ADDENDUM

NO. 1

PROJECT NAME: Tomball ISD Intermediate School Replacement

ADDENDUM DATE: Tuesday, July 28, 2026

1 ROOF FRAMING PLAN - AREA C
S6.08 1/8" = 1'-0"

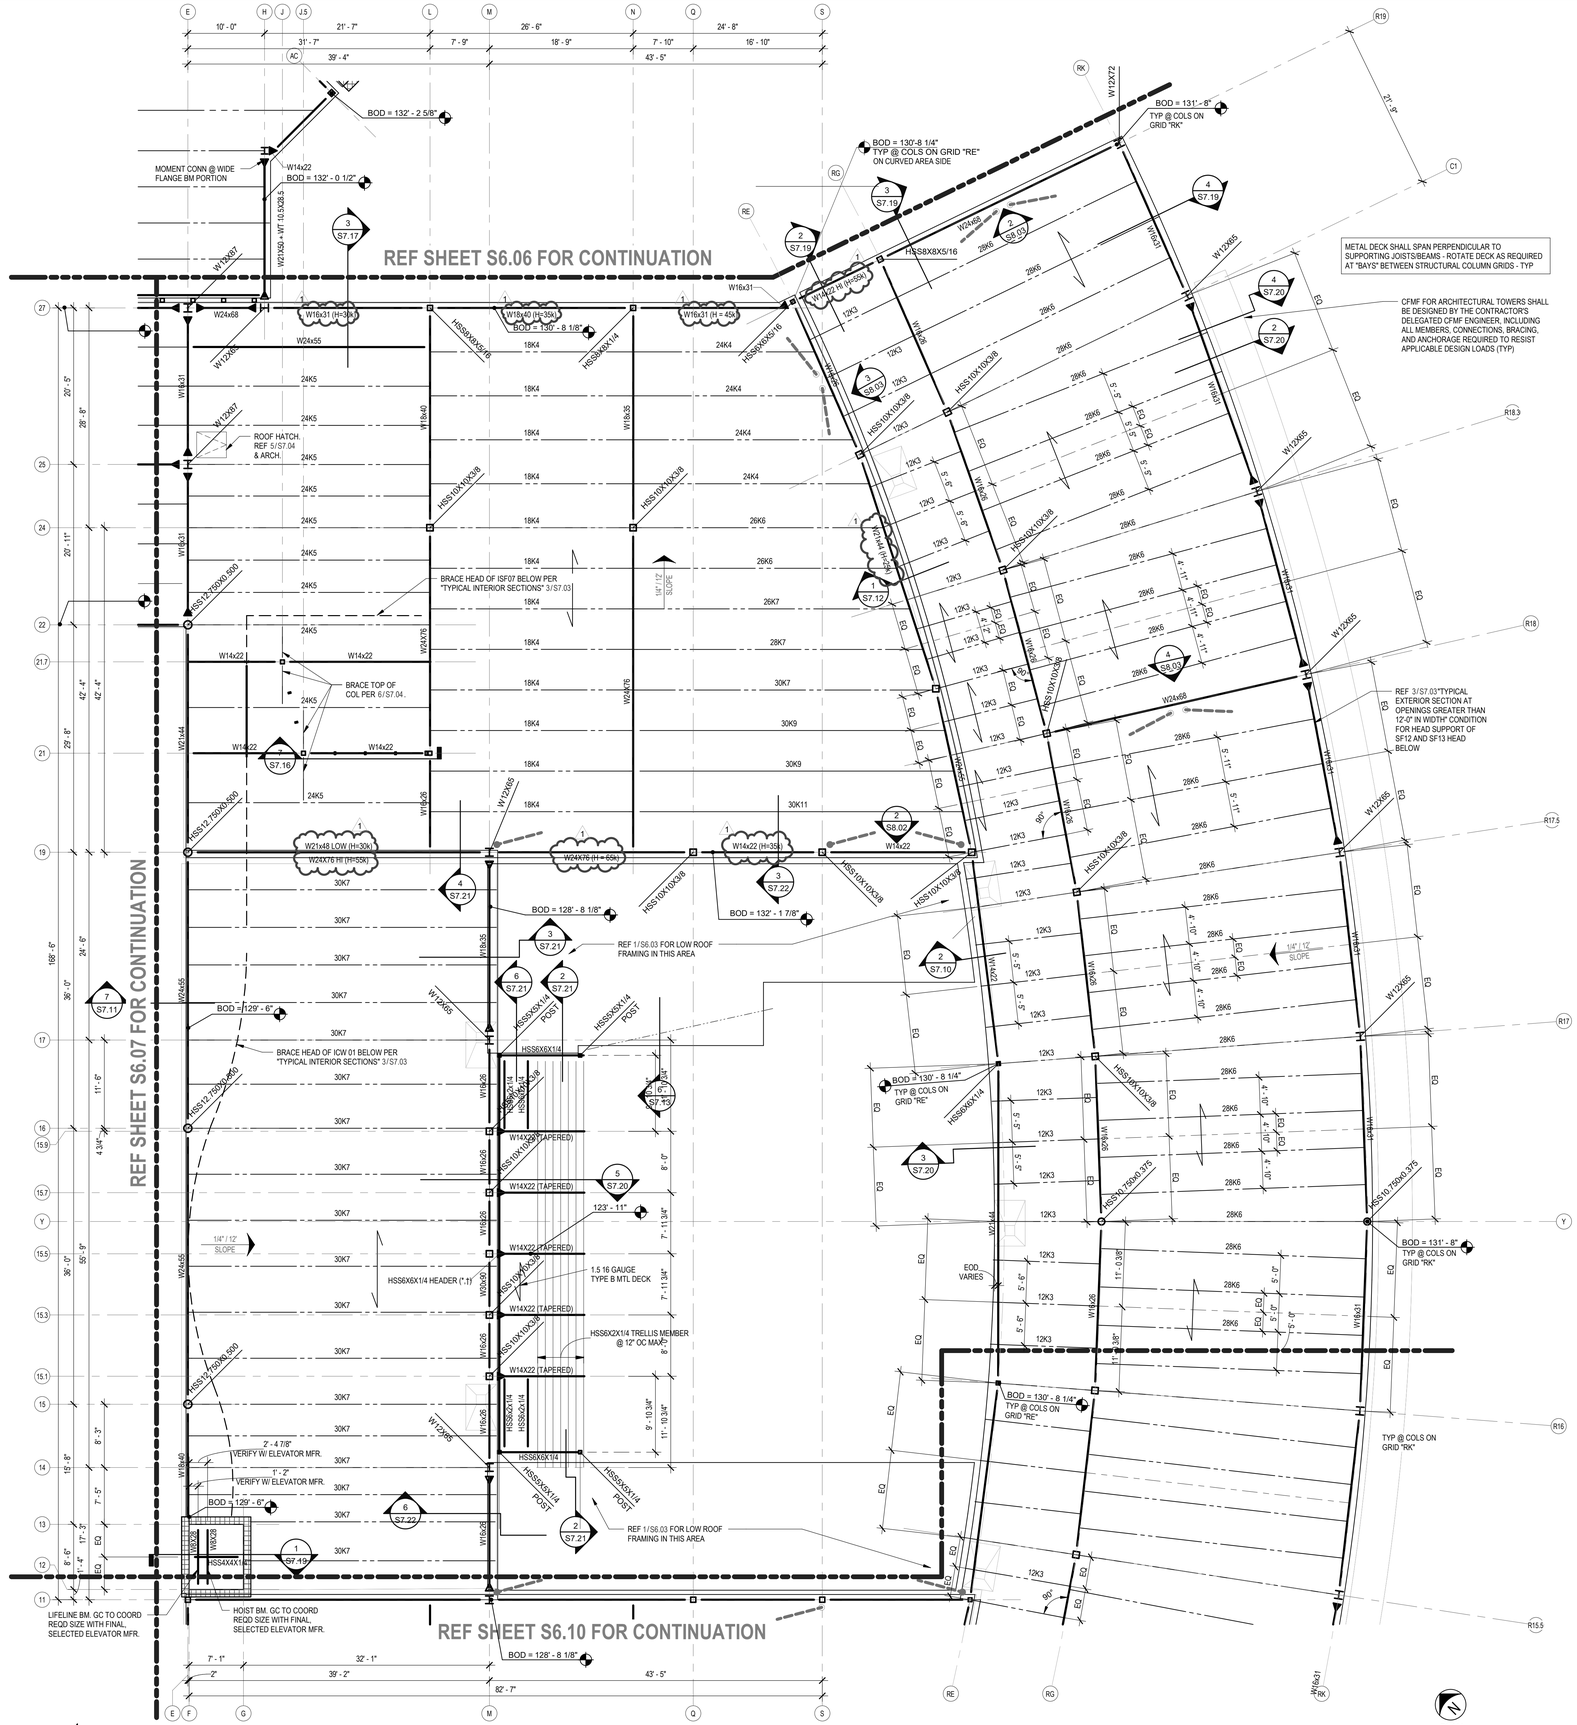
AD No 1, Struc. Item 6: To the Drawings, Sheet S6.08,"ROOF FRAMING PLAN - AREA C"
Added beam axial load notation.

1 ROOF FRAMING PLAN - AREA D
S6.09 1/8" = 1'-0"

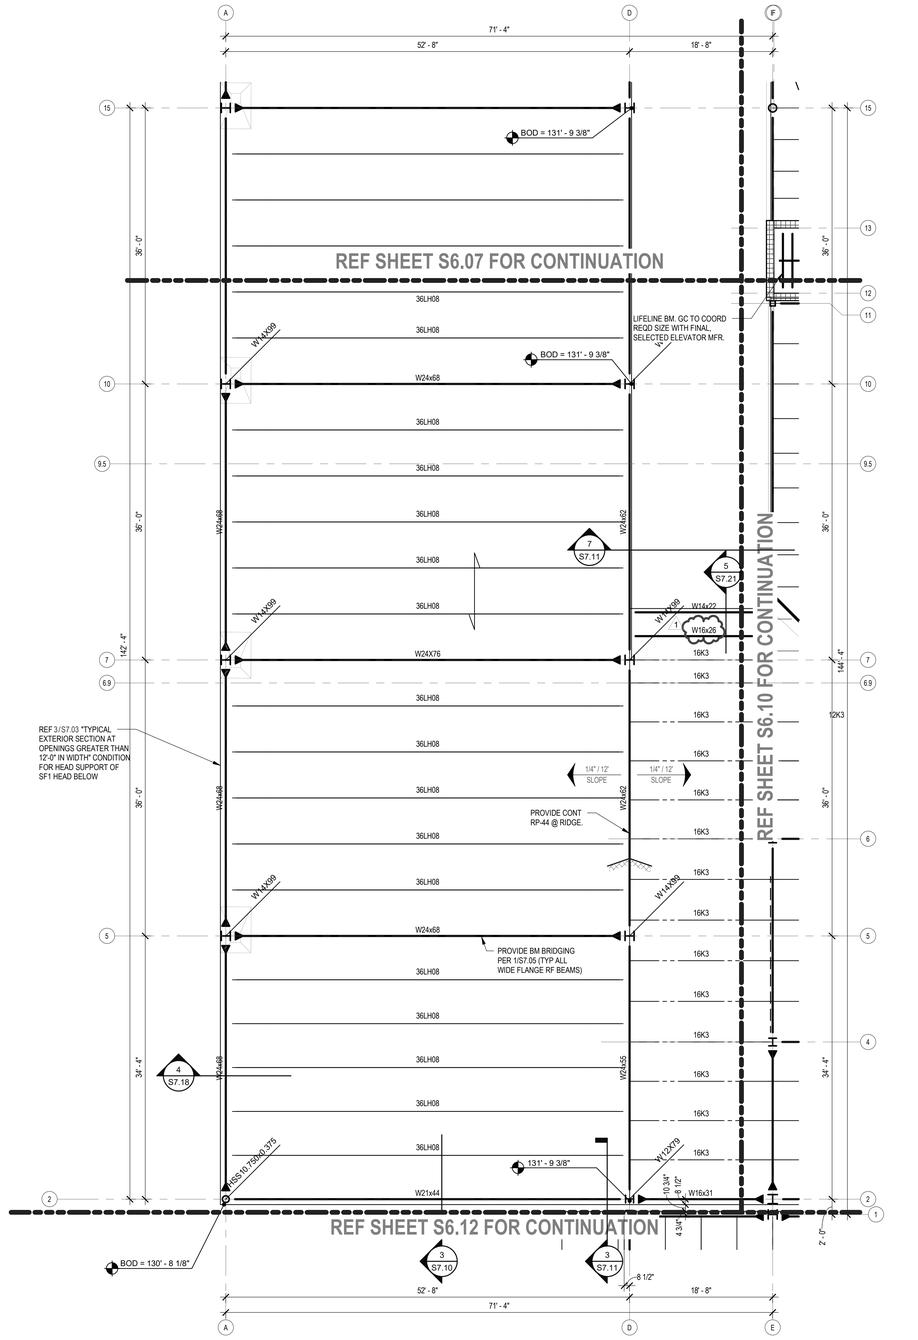
AD No 1, Struc. Item 7: To the Drawings, Sheet S6.09,"ROOF FRAMING PLAN - AREA D"
Changed roof purlin size.

1 ROOF FRAMING PLAN - AREA E

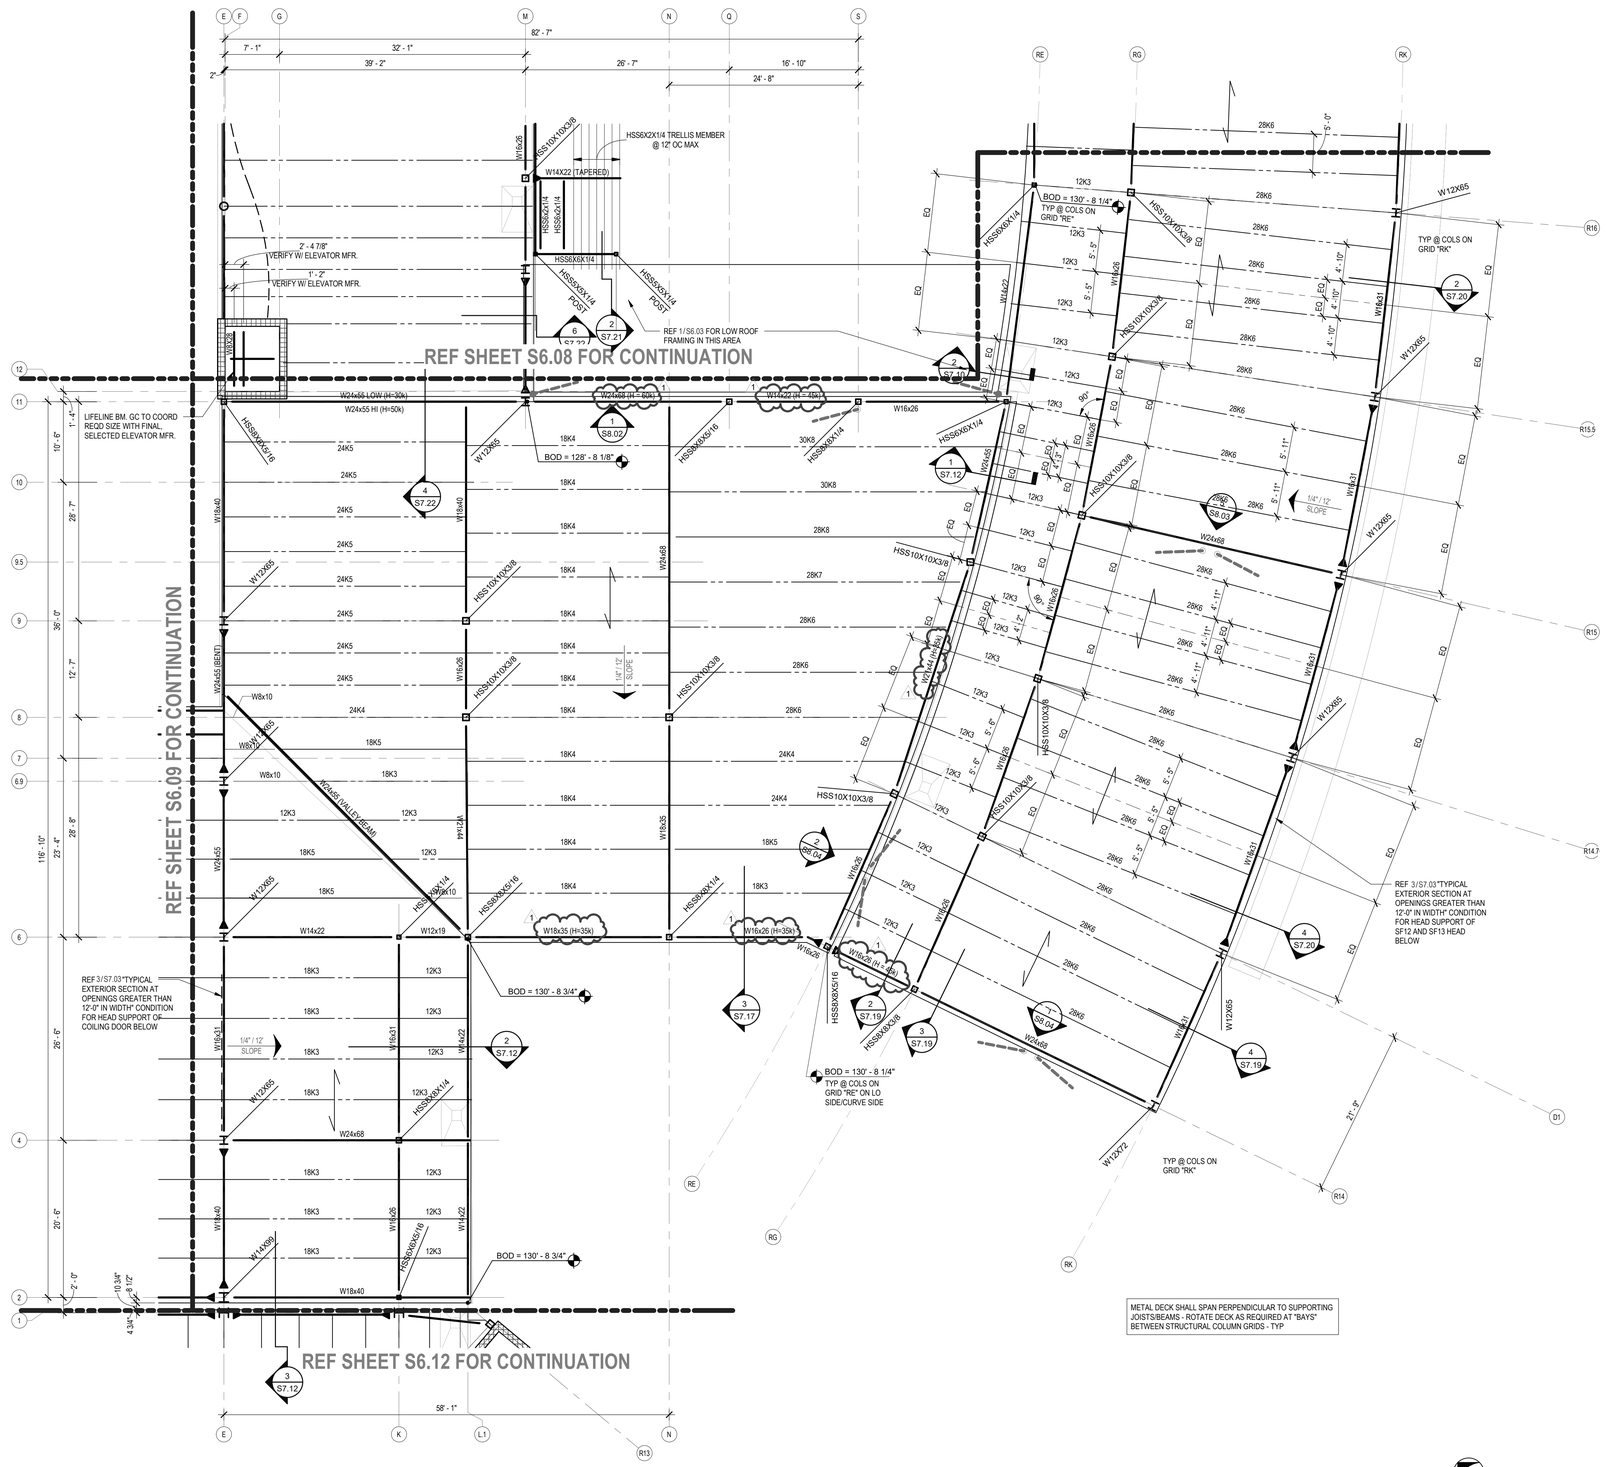
AD No 1, Struc. Item 8: To the Drawings, Sheet S6.10,"ROOF FRAMING PLAN - AREA E"
Added beam axial load notation.

1 ENLARGED FRAMING PLAN - LEARNING STAIR MID-LANDING

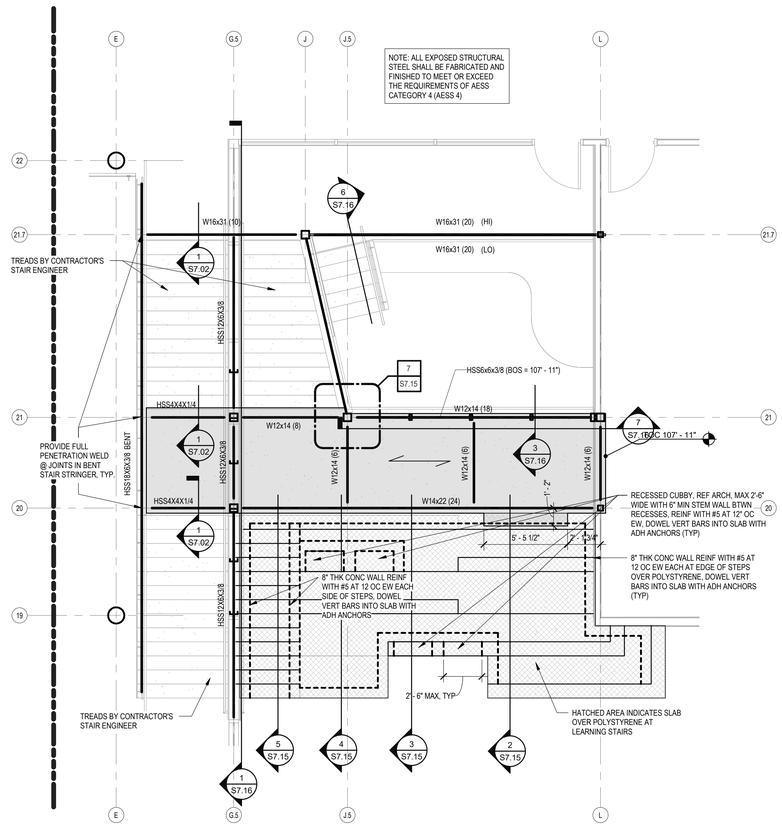
AD No 1, Struc. Item 9: To the Drawings, Sheet S6.13,"ENLARGED FLOOR FRAMING PLANS"
Modified learning stair/nest area.

1 ENLARGED PLAN - ROOF SCREEN
S6.14 1/4" = 1'-0"

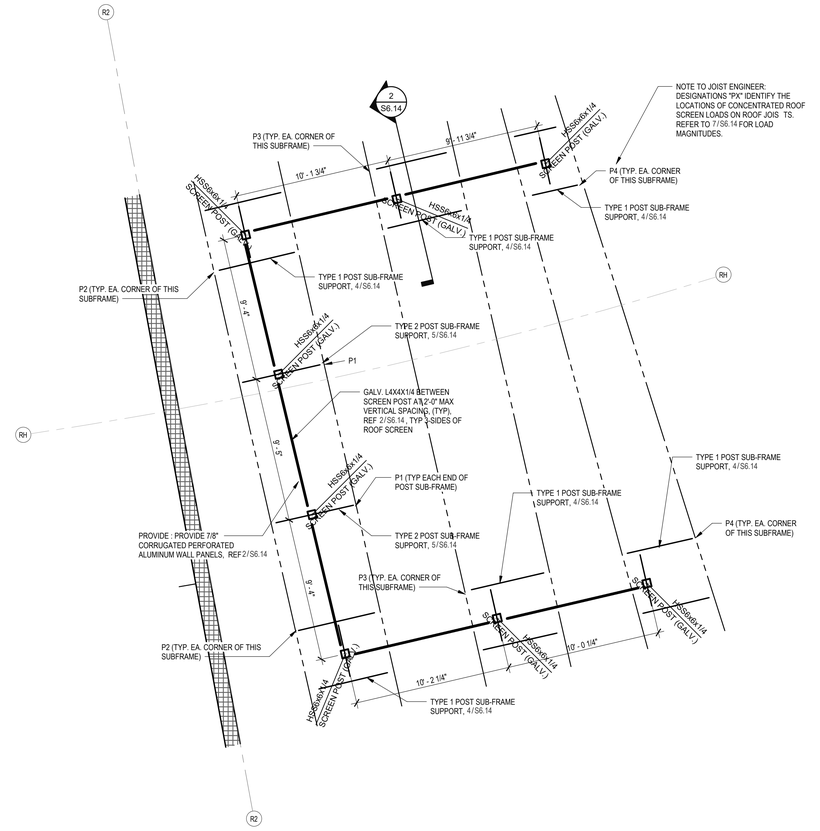
AD No 1, Struc. Item 10: To the Drawings, Sheet S6.14,"ROOF SCREEN PLANS AND DETAILS"
Added new sheet.

1 SECTION
S7.09 1/2" = 1'-0"

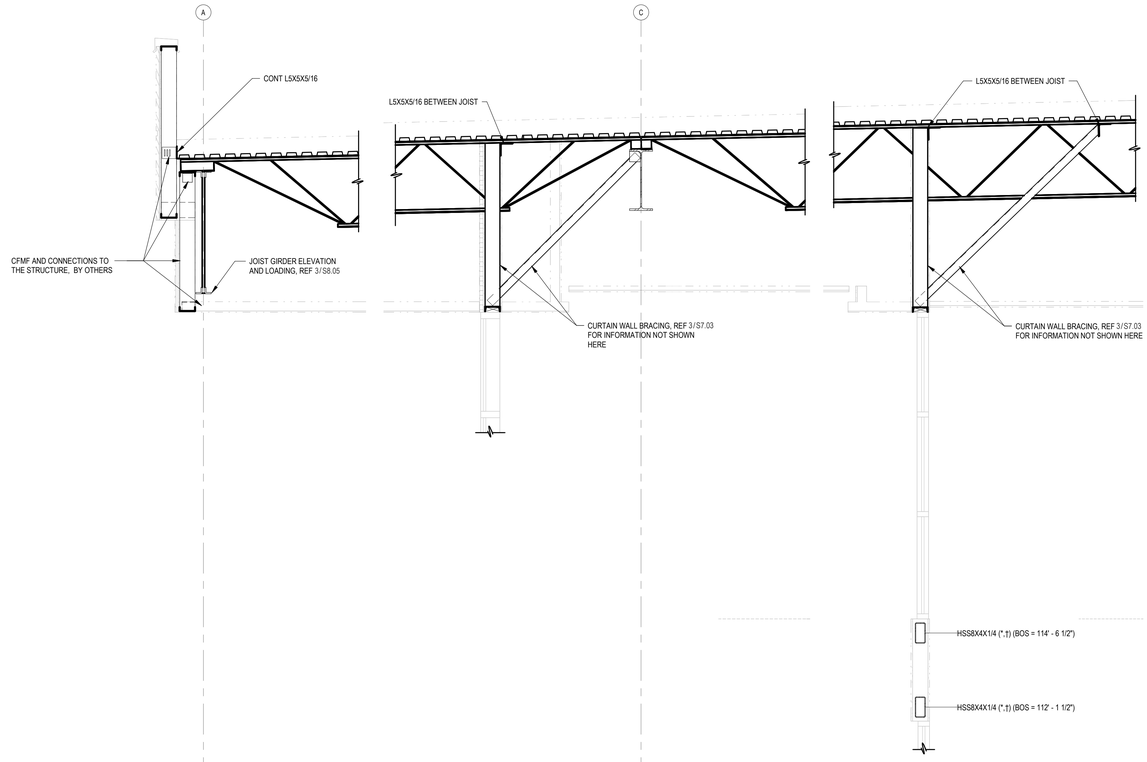
AD No 1, Struc. Item 11: To the Drawings, Sheet S7.09,"FRAMING DETAILS"
Revised detail.

1 SECTION
S7.16 1/2" = 1'-0"

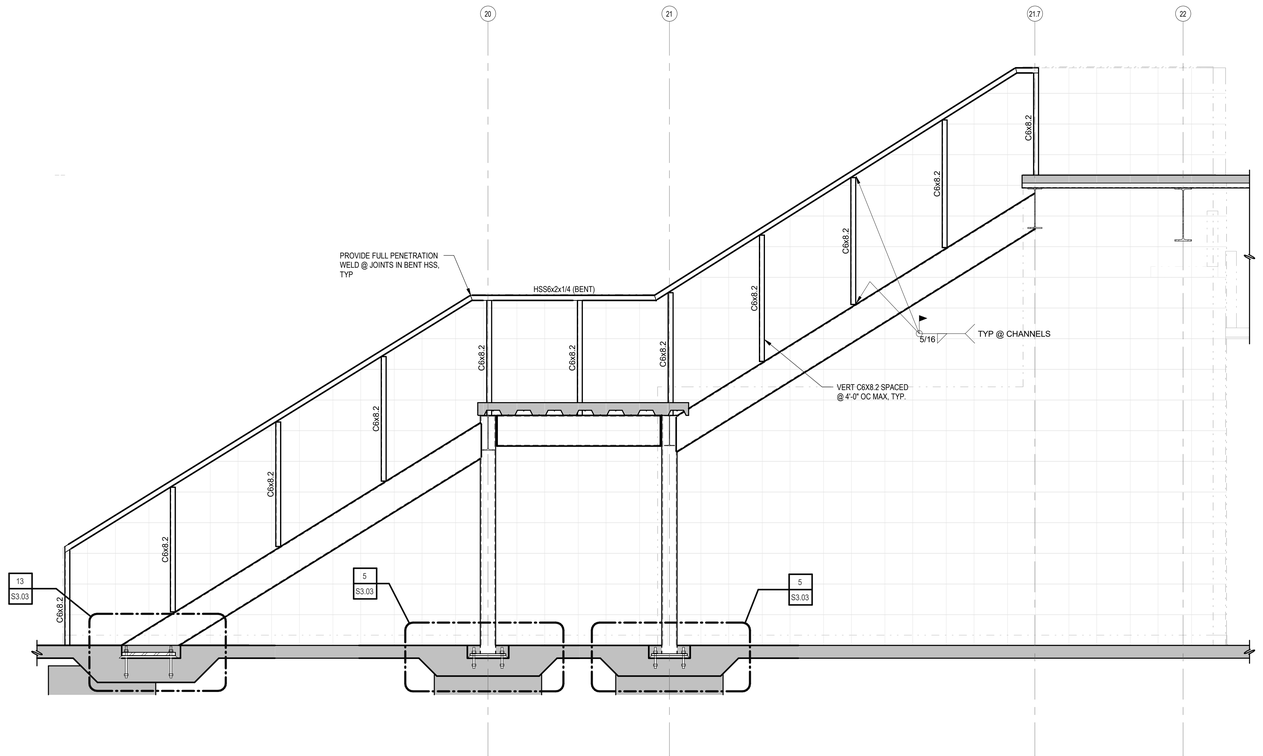
AD No 1, Struc. Item 13: To the Drawings, Sheet S7.16,"FRAMING SECTIONS"
Added, deleted, and revised details.
